Access Compliance Report

Public Rights-of-Way

(Curb Ramps)

Intersection ID: 25187	Main Street: BRIAR_RIDGE_DR	Cross Street: WEDDINGTON_RD	Location: NW
ADA ID: 2AE77FA29695	Ramp Type: PerpDiag	Initial Pass/Fail: Pass	Overall Compliance: No
Severity Score: 10.25			
Codes/Mitigation Info/Possible Solution		Field Measurements/Component Compliance

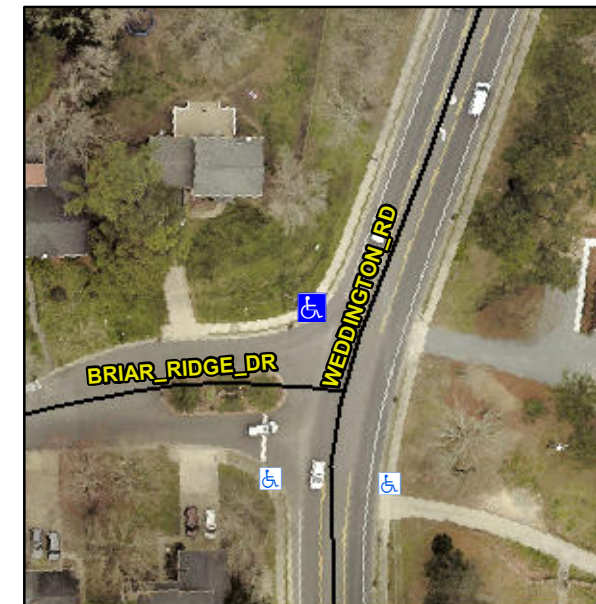
Not Found, R304.5.3, R304.2.1, R304.2.2-Perp, R304.3.2-Para

Remove & Replace Curb Ramp With Two New Directional Ramps or Equivalent. Remove & Replace Gutter.
